Product Change Notification / SYST-25ZHBH424

ERRATA - PIC16(L)F19155/56/75/76/85/86 Family Silicon Errata and Data Sheet Clarification

Description of Change: Added DS Clarification, Module 2: Pin Diagrams.

PIC16(L)F19155/56/75/76/85/86 Family Silicon Errata and Data Sheet Clarification

FIGURE 1: 28-PIN SSOP, SPDIP AND SOIC PIN DIAGRAM FOR PIC16(L)F19155/56

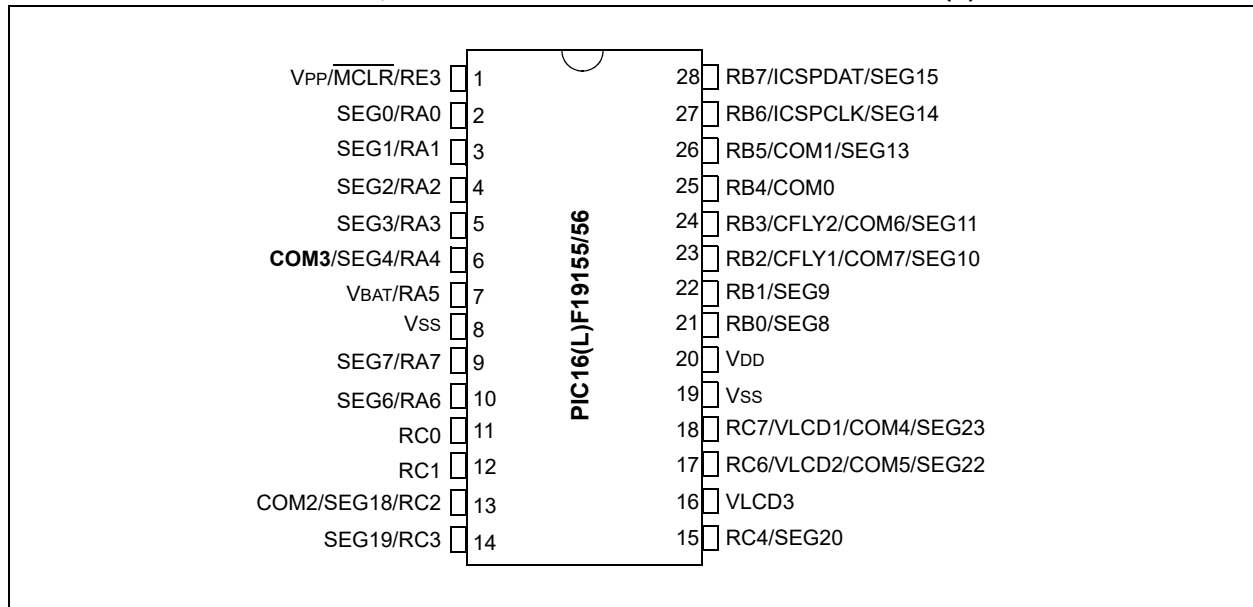
2.1 Pin Diagrams, Figure 1

The COM0 function multiplexed to RA4 is changed to COM3, as shown below.
